**Re: FortisBC Inc. (FBC)**

**Project No. 1598987**

**Application for a Certificate of Public Convenience and Necessity (CPCN) for the Grand Forks Terminal Station Reliability Project (the Application)**

**Response to the Industrial Customers Group (ICG) Information Request (IR) No. 2**

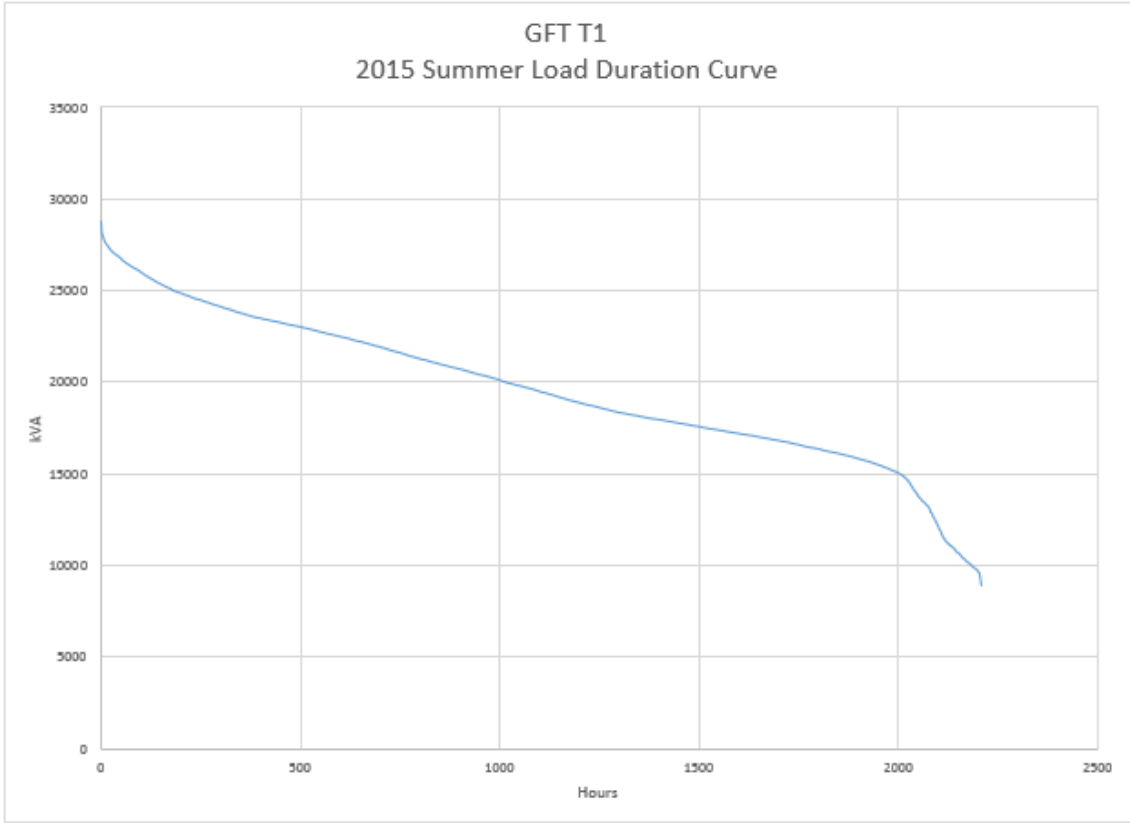
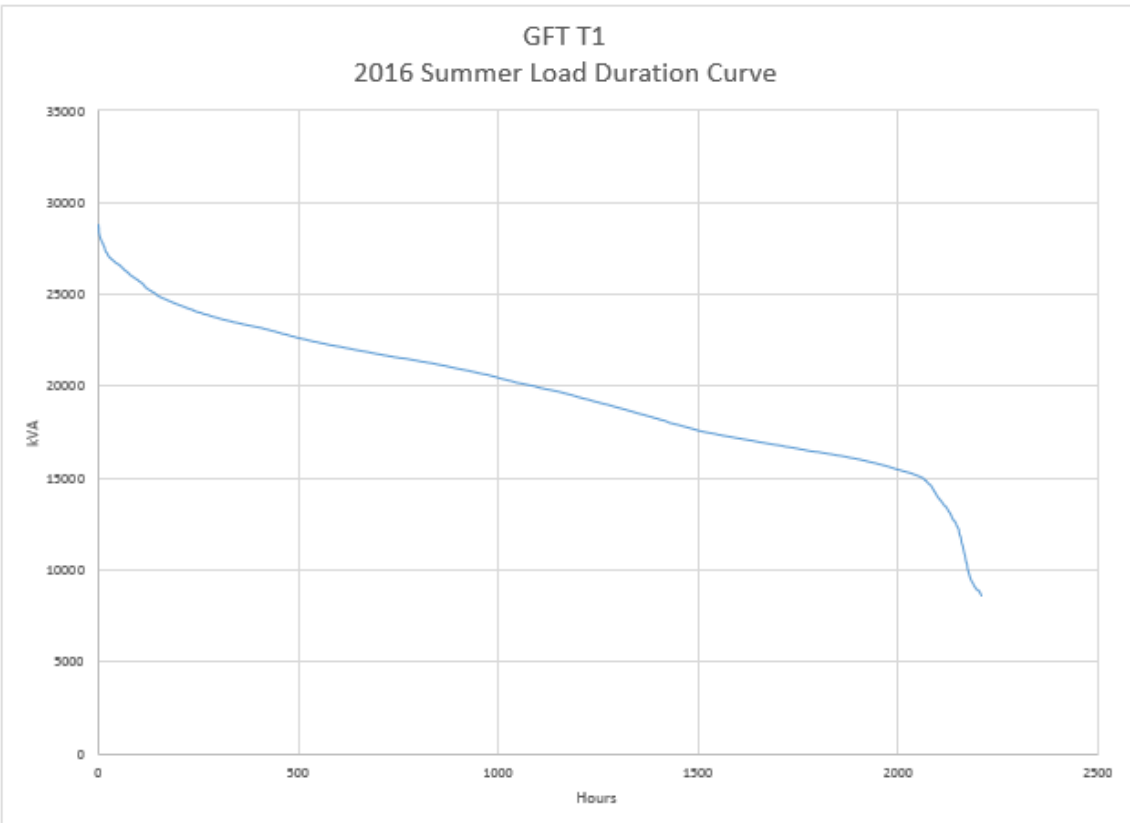
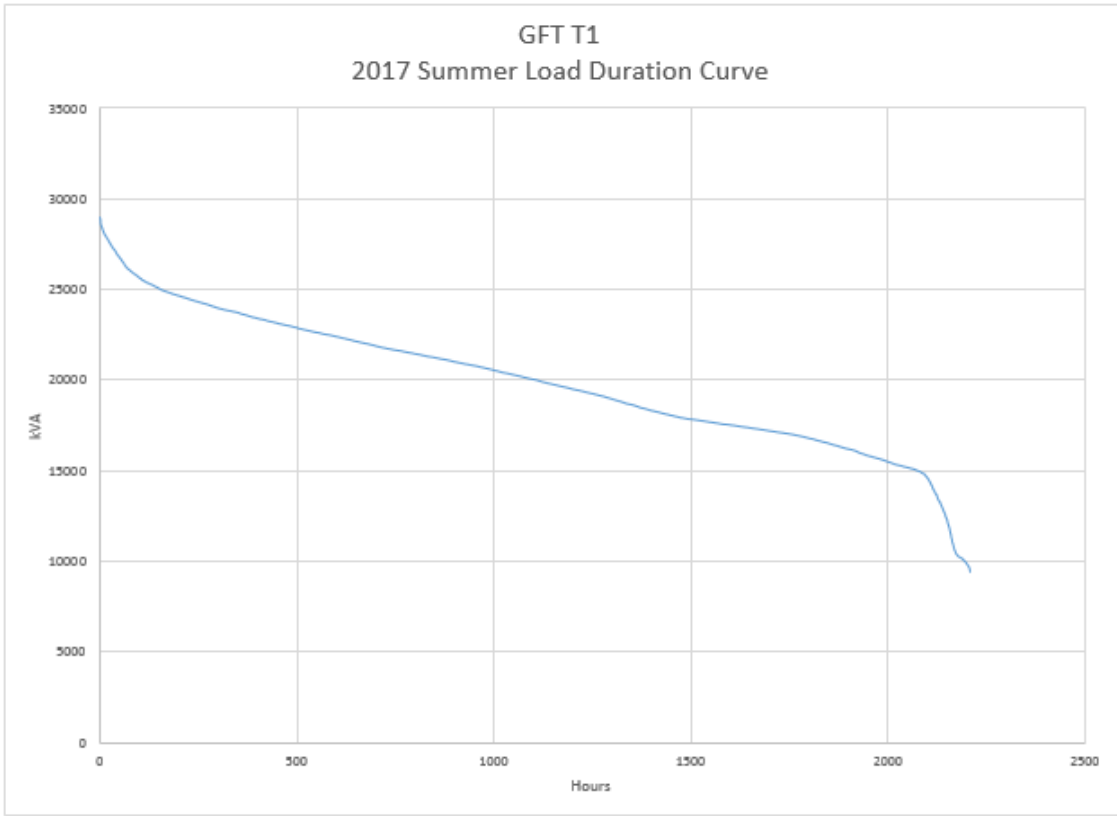
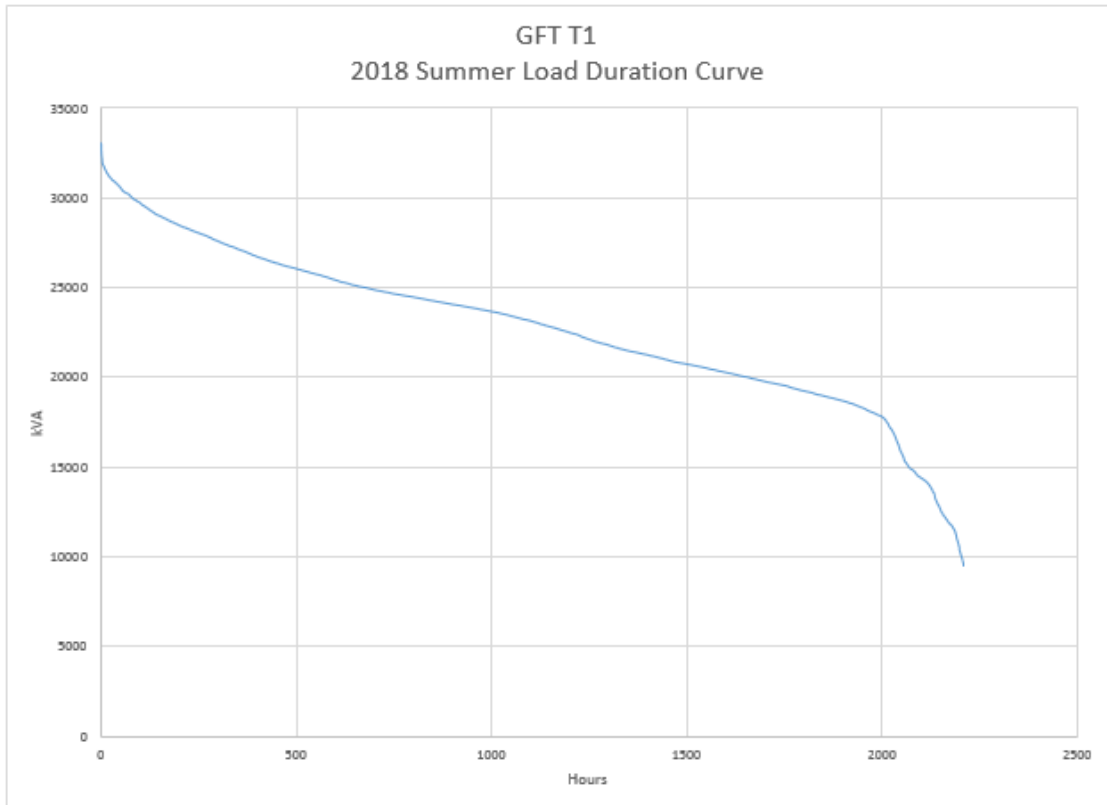
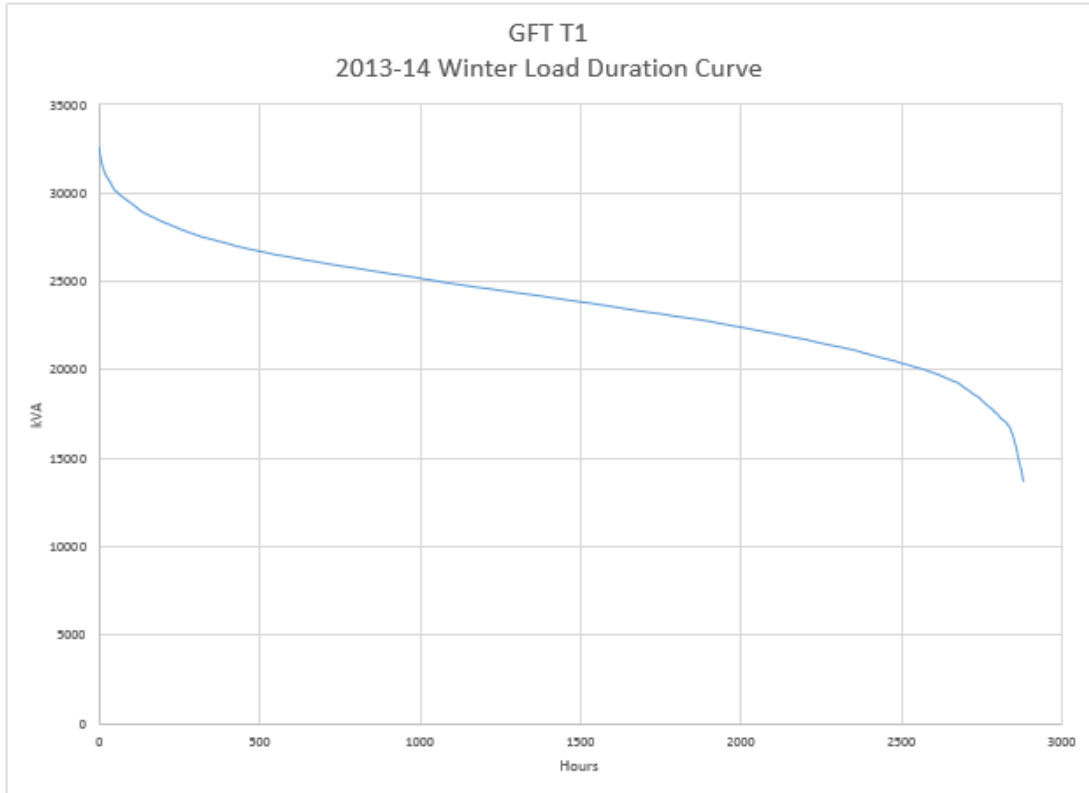
2            14.1 Please re-format the data supplied in the spreadsheets submitted in Exhibit B-5,  
 3            CEC IR 1.7.1 as traditional load-duration curves so that the number of hours  
 4            where the transformer was carrying above a given load can be readily  
 5            determined.

8    The summer season load duration curves for GFT T1 over the past five years are provided  
 9    below.
